Regular Meeting of the Historic Districts Review Board
June 23, 2026, at 5:30 PM
Council Chambers, City Hall
200 Lincoln Avenue
Santa Fe, New Mexico

Meeting Minutes
View meeting on City YouTube: https://www.youtube.com/watch?v=T9qhhTyNFZI&index=24

e. **2026-012490-HDRB, 507 Paseo de Peralta, Downtown & Eastside Historic District.** Marisol Ortiz, agent for Peralta's Walk LLC, owners, proposes to construct a 4,235-square-foot, multi-family residence to a height of 24 feet, where the maximum allowable height is 25 feet, on a vacant lot.

507 Paseo de Peralta
Bldg Height
Total 242.20
Count 12
Avg 20.18
Max 22'2"
10/1/26
PASEO DE PERALTA
BISHOPS LODGE RD
KEARNY RD
KEARNY AVE
OTERO ST
S FEDERAL PL
LINCOLN AVE
WASHINGTON AVE
W MARCY ST
E MARCY ST

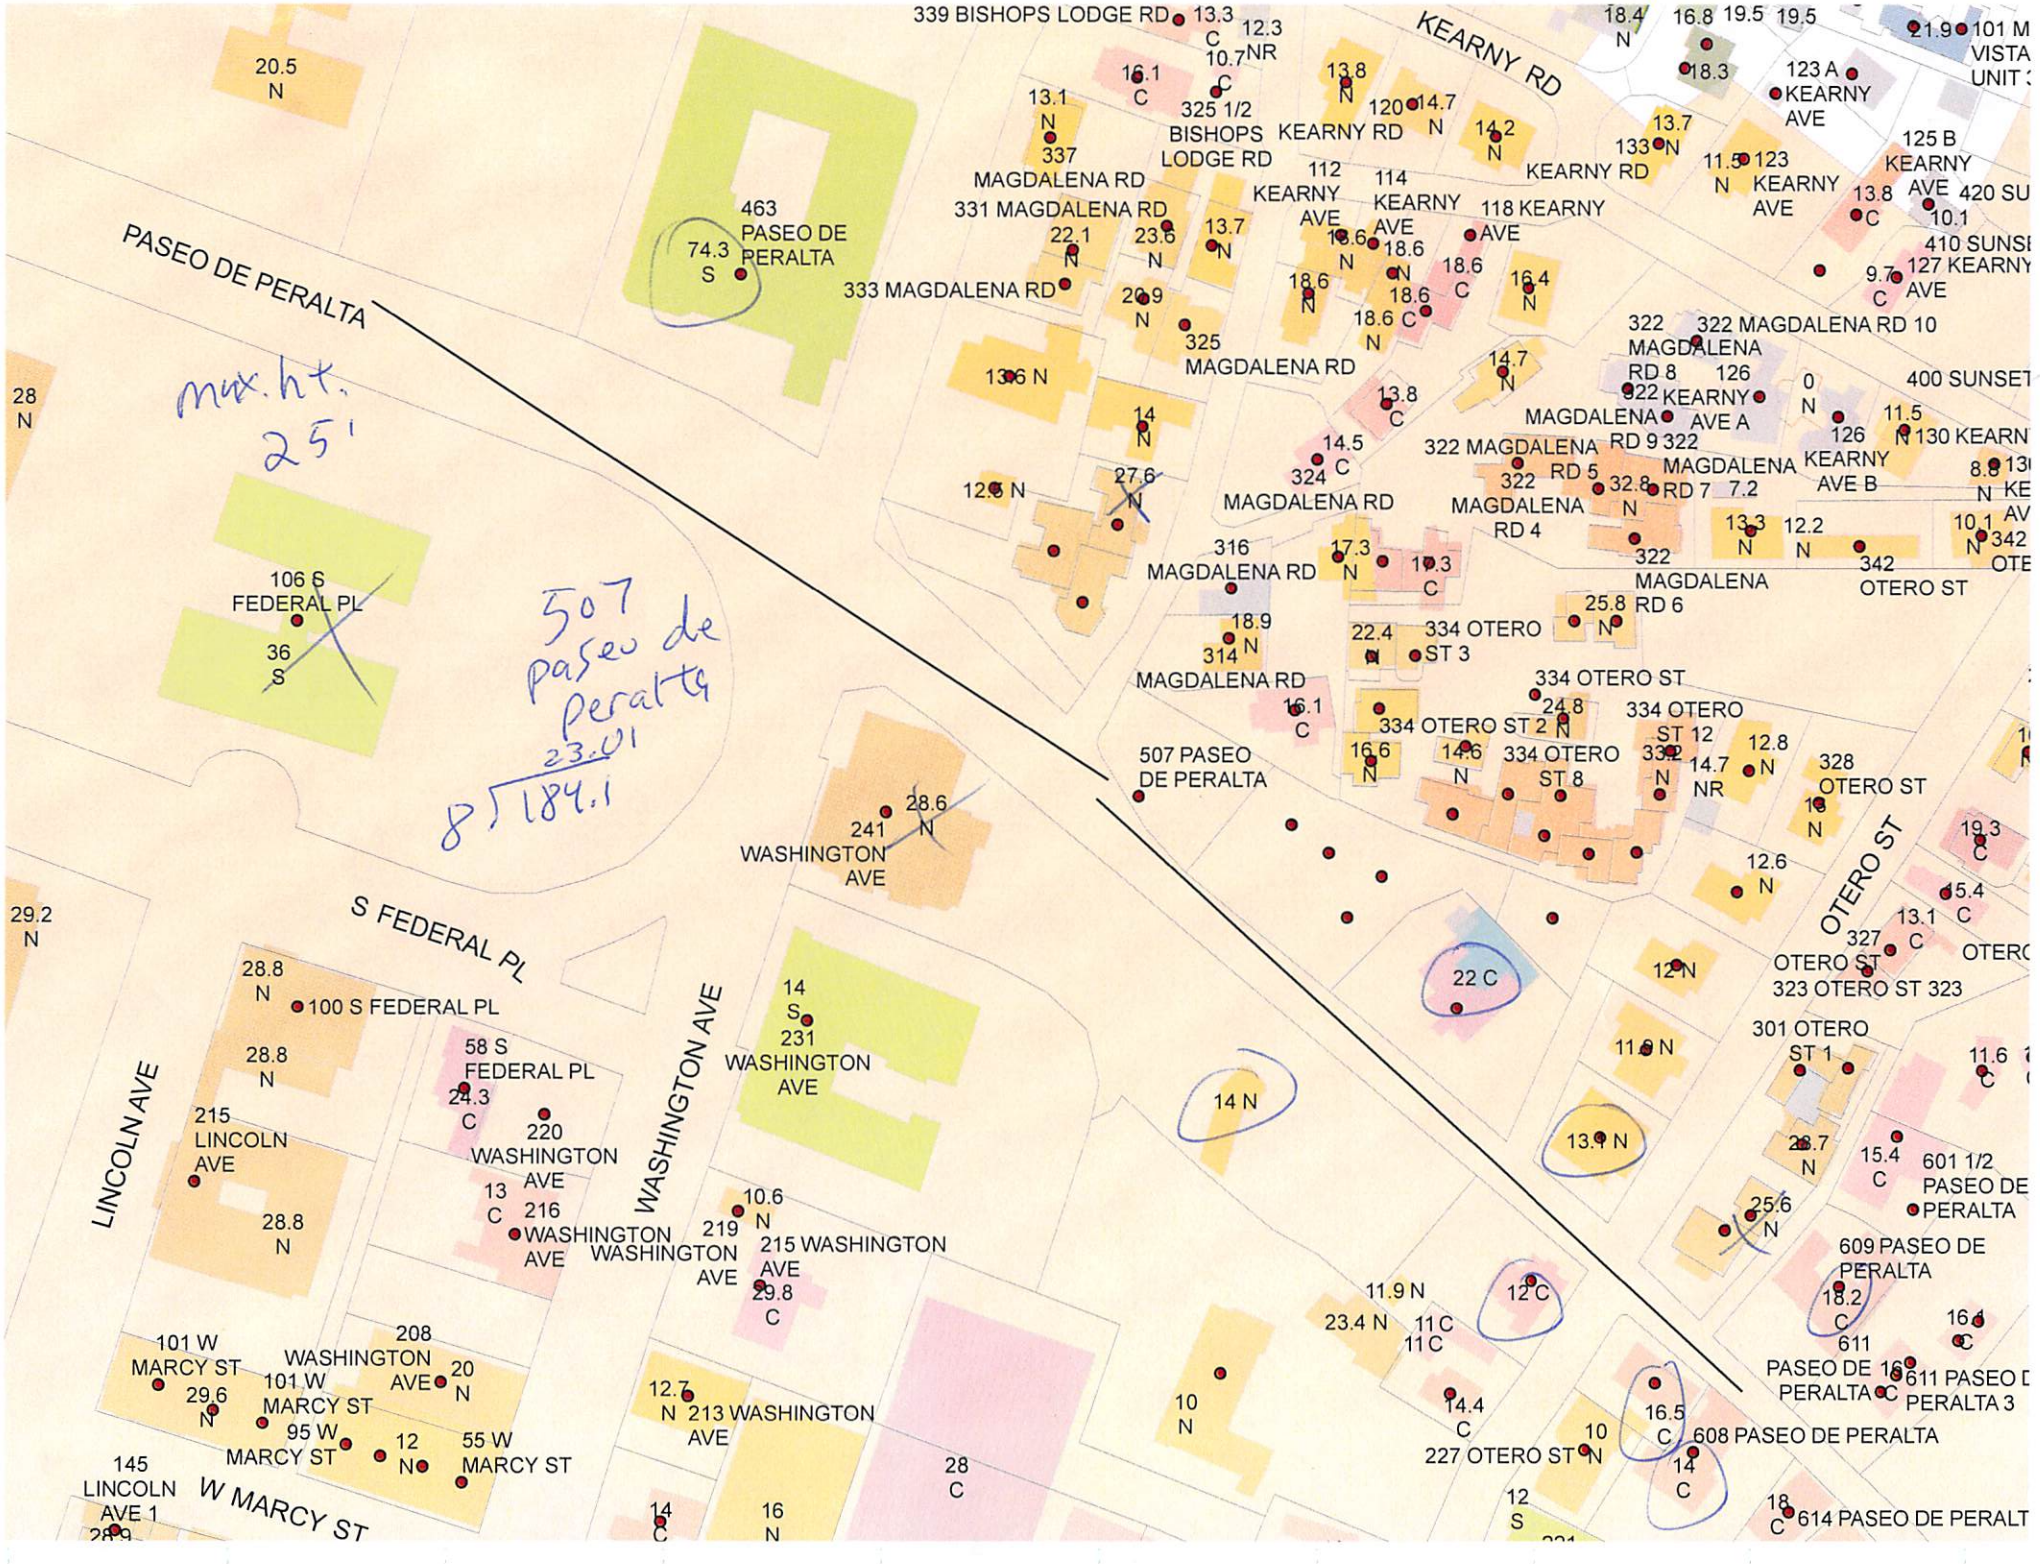
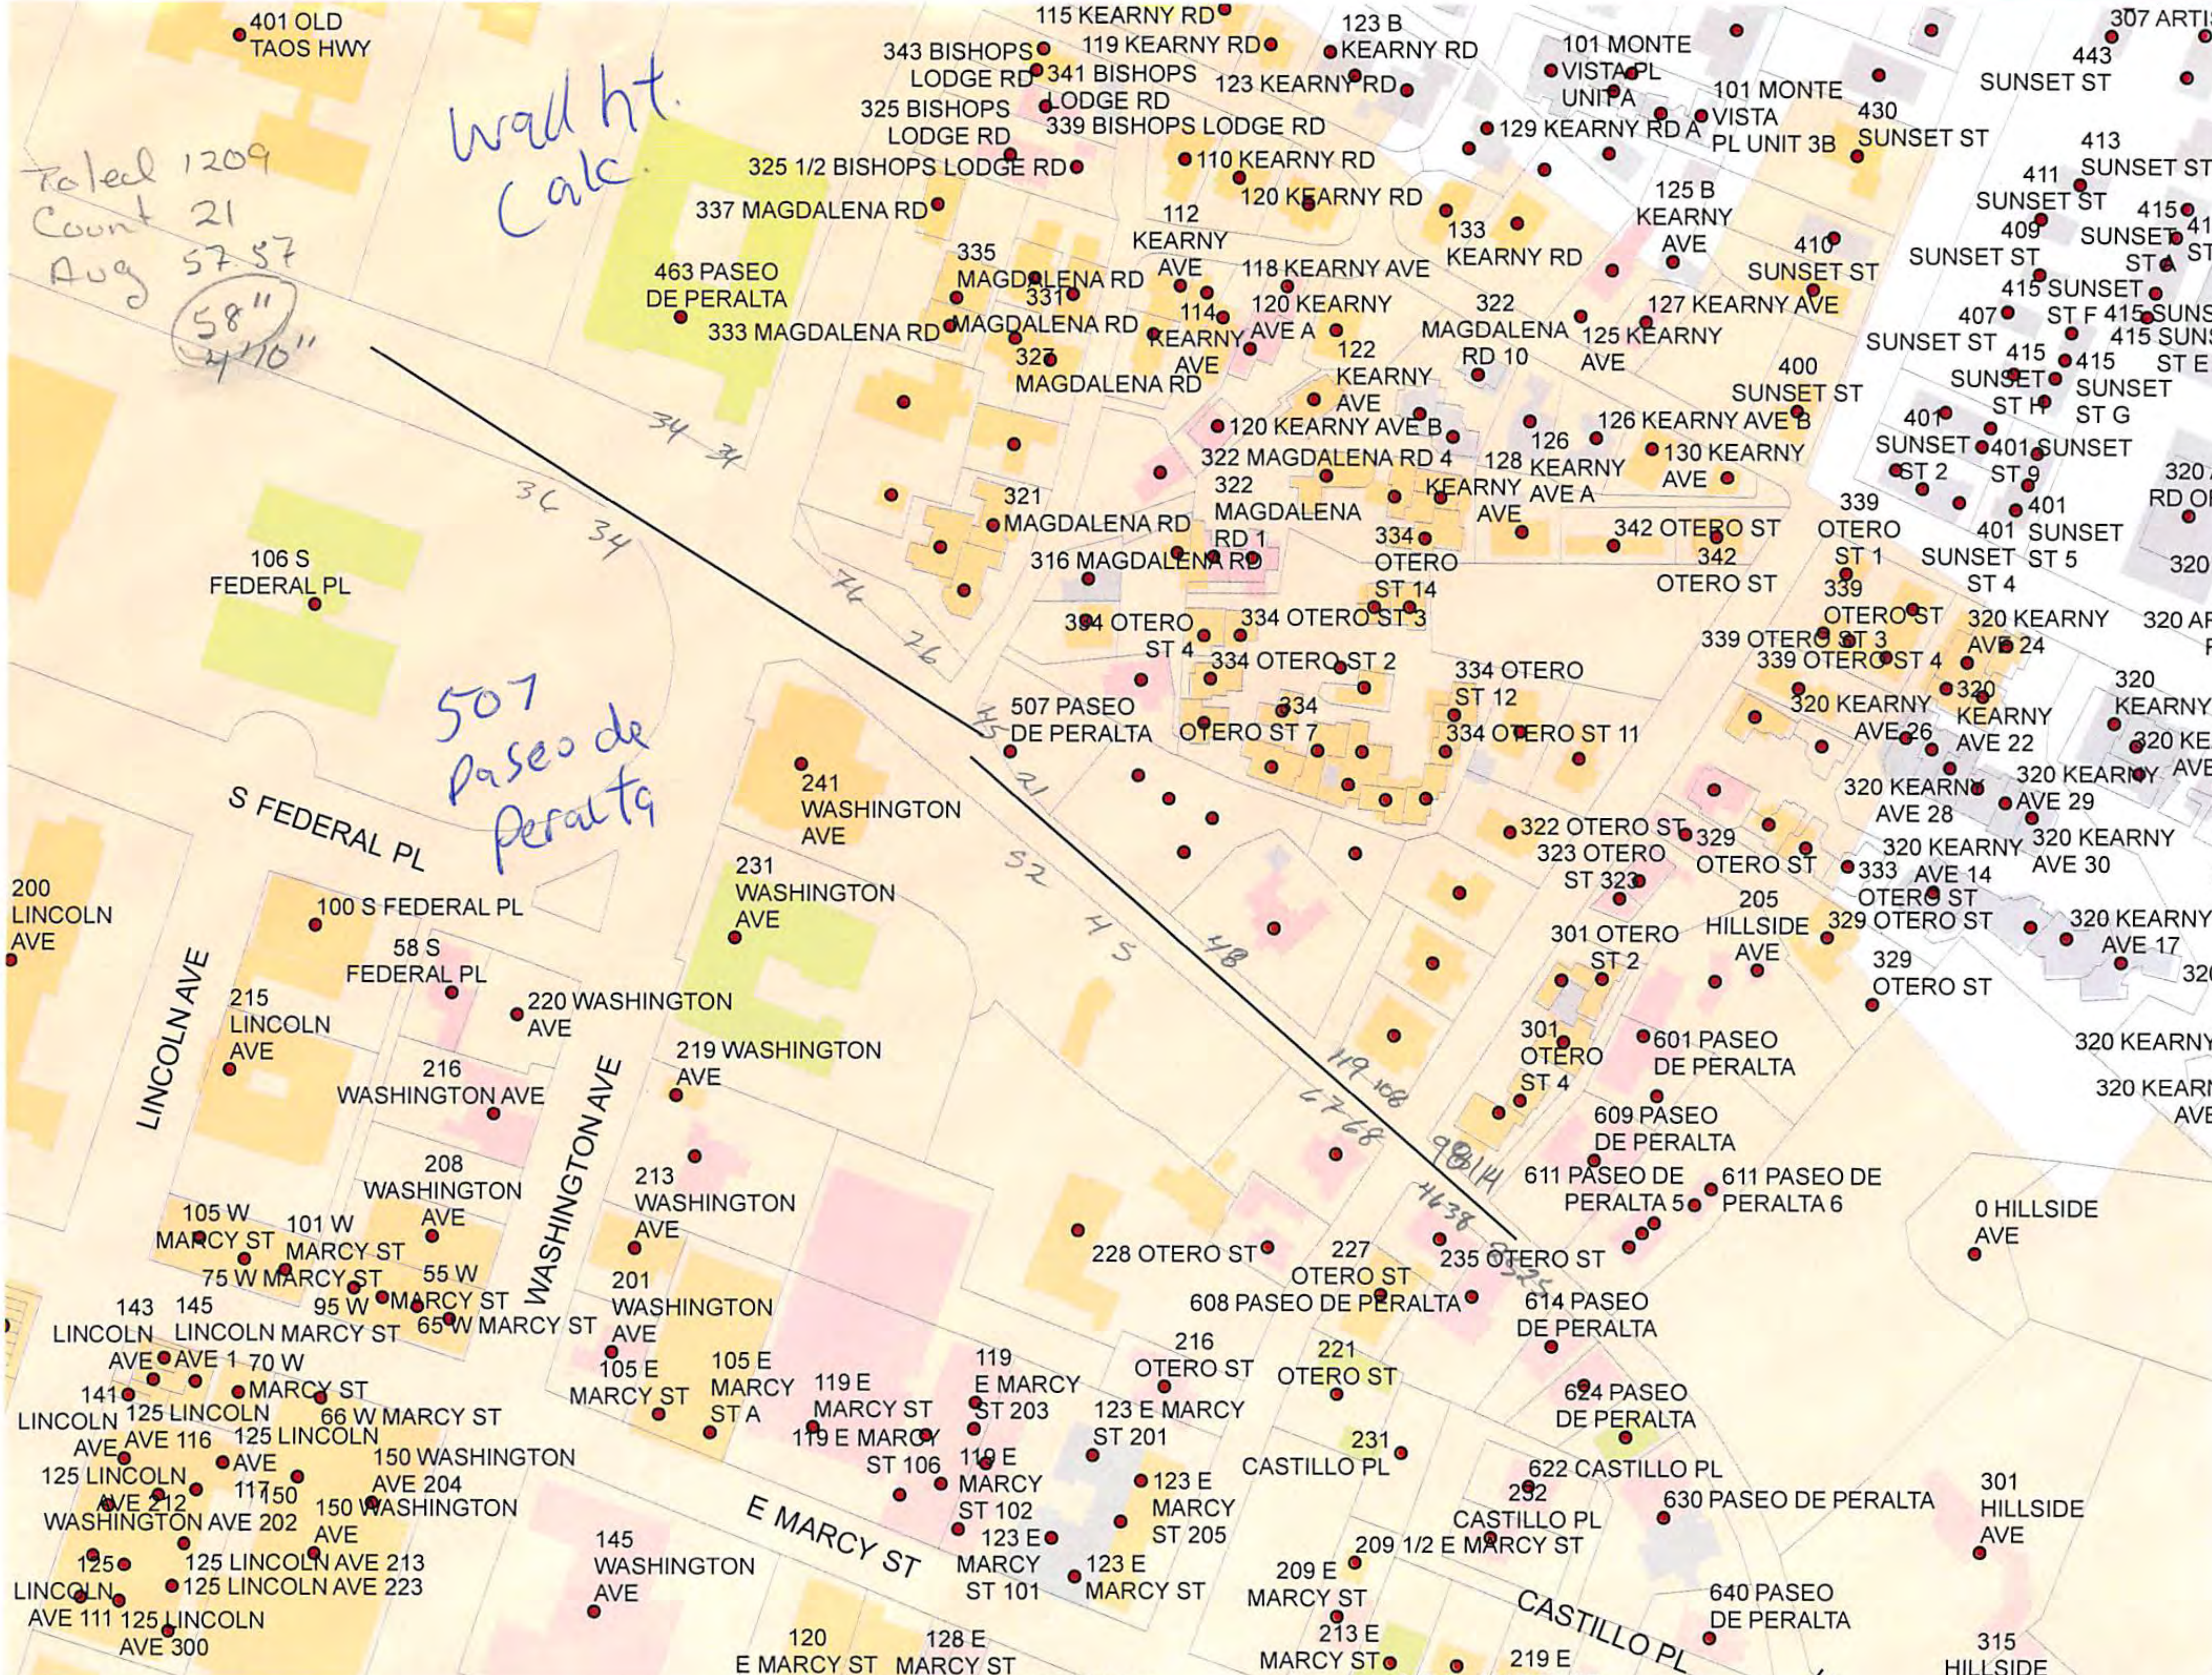
The maximum allowable building height is 22’-2”.

**The difference between this calculation and the previous calculation is that the previous calculation did not take the streetscape along Magdalena into consideration. This is a corner lot and should have taken both streetscapes into consideration.
